TMC SPECIFICATION NO. S-200

TITLE: Modification of FFR

BEFORE CHANGE

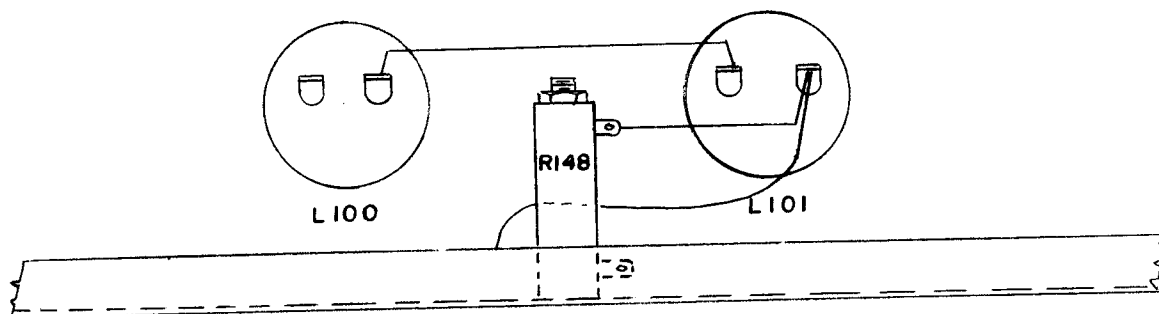
Remove the power supply side cover plate. The choke (L101) lug, directly under the 20 watt resistor R148, contains two red leads. One lead connects both chokes L100 and L101; the second goes directly to a power supply cable. Remove the second lead and connect it to the other lug of L101 (same choke). This change completes the modification. Replace side cover plate. Illustration below should be checked to insure proper wiring.
